SELECTIONS
FROM
THE RECORDS
OF
THE BENGAL GOVERNMENT.

PAPERS OF 1853 AND 1854

DAMOODAH EMBANKMENTS,
&c, &c, &c

PAPERS OF 1853 AND 1854
ON THE
DAMOODAH EMBANKMENTS,
&c, &c, &c.

Fig 1

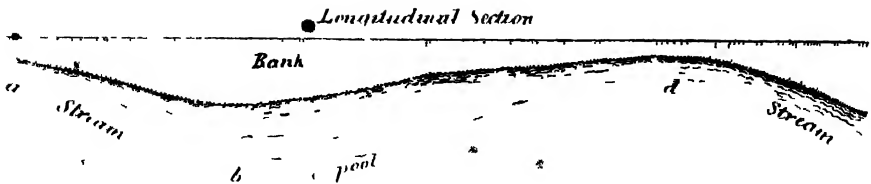
At *Fig. 1.* is a stream, which moving (on the principle of falling bodies) with an accelerated velocity as it descends the slope, acquires at *b* the power to excavate its bed and form a pool, *c*; but this process is destructive of its own power and a counterfall is thereby established from *c* to *d*. A similar process is then commenced from *d* where the natural fall restores the power. The counterfall *c d* acts as an obstacle to the direct course of the stream, and being from that cause no longer able to overcome the resistance of the bed, it acts laterally on the banks, which become farther apart as you approach *d*, the current getting feebler, till top of the counterfall gained, the equilibrium is restored and the same process is repeated. It is thus that *Fig. 2* can be traced from *Fig. 1*, and the plan drawn from the Section. Thus it is that Nature deals with river beds, and the effect above described must have been witnessed by every one who has seen a river in the dry season, which plainly discloses the operations that have been carried on during the season of flood which is the real governing state of the river.
